DM/25/3067 Erection of 80 new residential dwellings (Use Class C3), including affordable housing units, vehicular, pedestrian and cycle access (including new footpath links to the east and west of the site along Reeds Lane), landscaping and open space, parking, sustainable drainage and other related works. (Site levels and drainage note received 16/1/25. Transport Note, Travel Plan Statement, Landscape and Visual Appraisal, GCN Technical Note and amended plans received 17/4/25). Land West Of Kings Business Centre Reeds Lane Sayers Common West Sussex

Flooding across Reeds Lane by the south west corner of the site. Left 16/11/2022, centre 01/01/2023 & right 05/01/2025

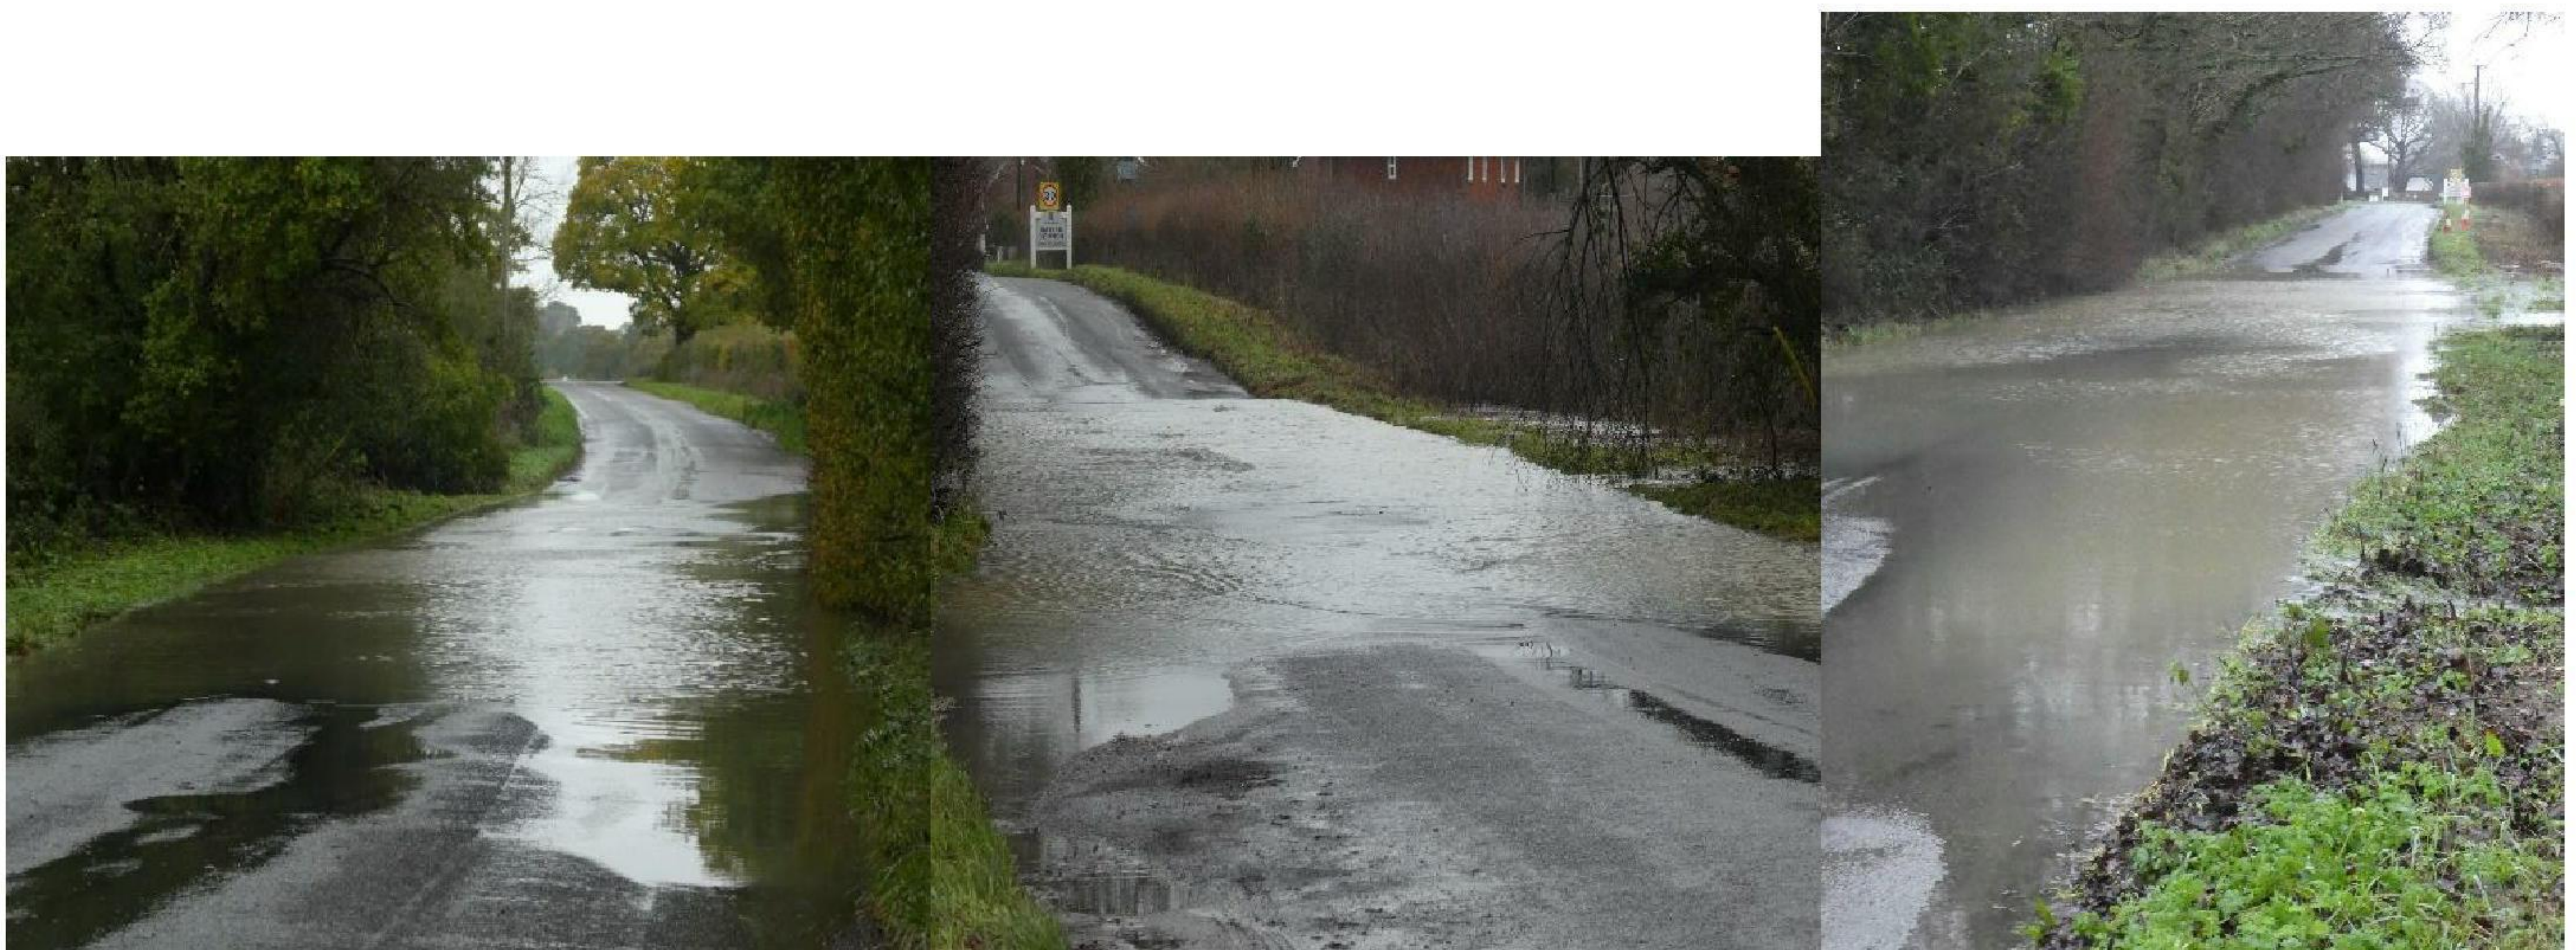
i) The Reeds Lane highway regularly floods at the south west corner of the site. There are numerous records of this flooding recorded in WSCC Highways own Site History Report for Reeds Lane. However, neither WSCC Highways, WSCC LLFA, MSDC or the applicant make any reference to this flooding or examine the impact of the site on it. That is a complete lack of due diligence which opens up both WSCC and MSDC to incurring costs and liabilities as a result.

ii) This flooding covers the whole of the roadway and its verges, all land which is owned by WSCC Highways. It is caused by WSCC's under road culvert not being large enough to carry all of the water from the watercourse in periods of heavy rain. The water therefore overflows and floods the roadway and verges.

Extracts from the applicants General Management Plan Sheet Two showing their proposed planting for the area of bluebells at the northern edge of the site.

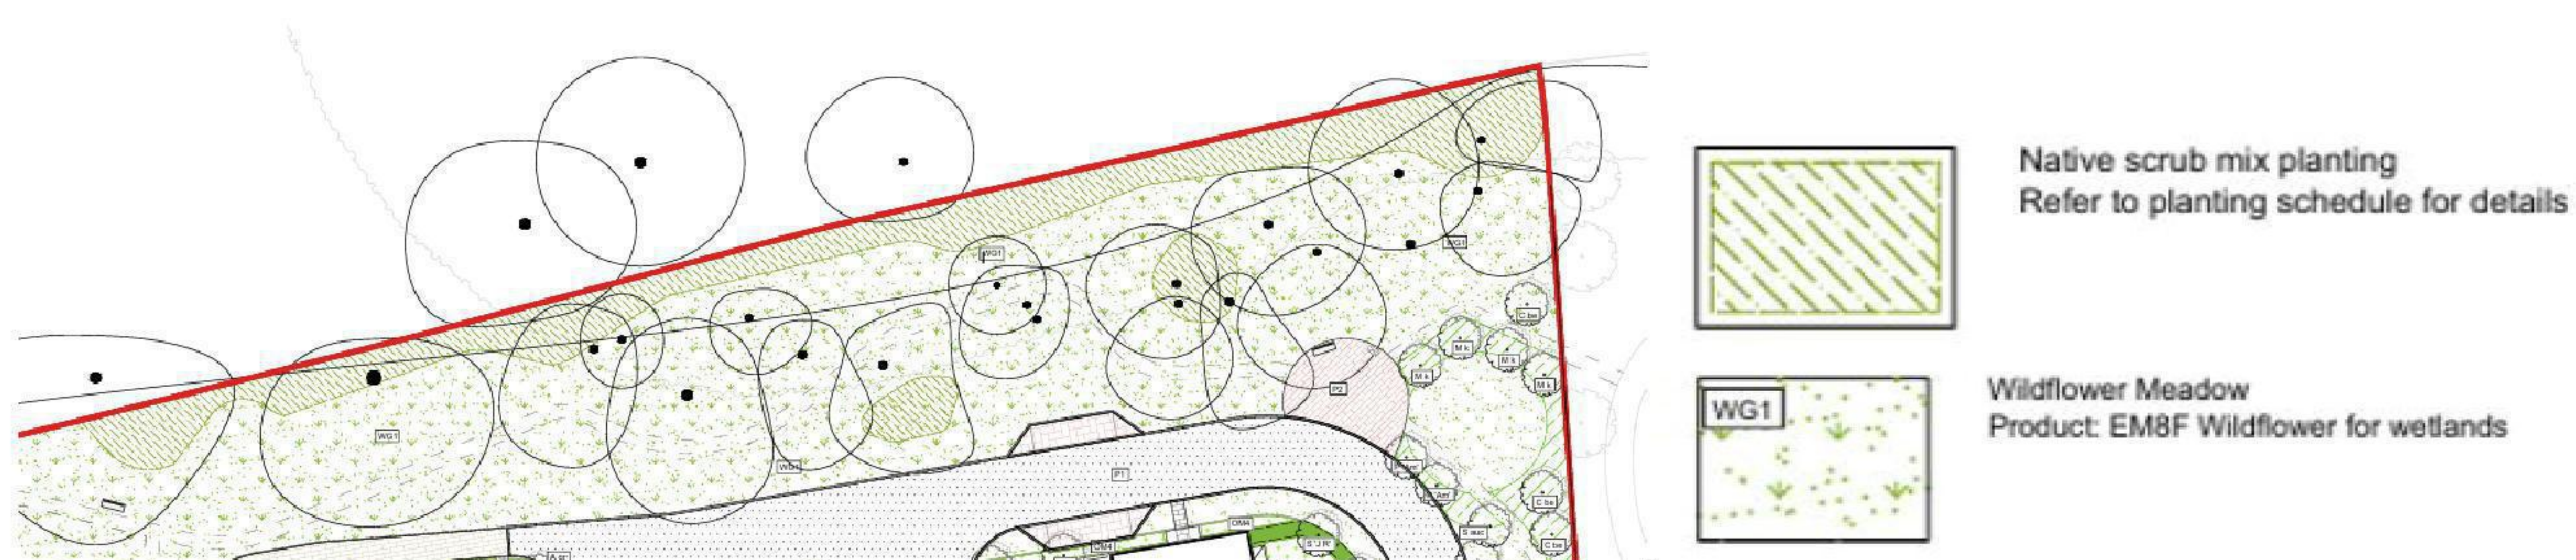
iv) The applicant gives no mention of how they will manage the bluebells on their site or protect them from the above risks. Their General Arrangement Plan Sheet two advises that the area where there the bluebells are currently growing in is to have a Native Scrub Mix Planting. It refers to the planting schedule for details but there is no mention in that schedule of such planting so it is not known what exactly they are planning to plant in this area. They advise that the planting next to that is to be a wildflower meadow using wildflowers for wetland seeds which they are using all over the site. Although most of the rest of the site is prone to flooding and waterlogged ground, the area by the woodland is mainly dry so that planting is not suitable. These issues bring into question the applicant ability to manage the protected bluebells on their site.

v) The applicant is proposing to have some paths in this area but gives no details of these. With the sudden introduction of houses in the field there will be more people accessing this area so there is a real risk of the bluebells being trampled or picked. The introduction of domestic gardens into the field also raises the risk of Spanish Bluebells being planted in gardens. No details are given of how the bluebells will be protected during the construction phase. There is therefore a high risk of offences being committed under the Wildlife and Countryside Act (1981).
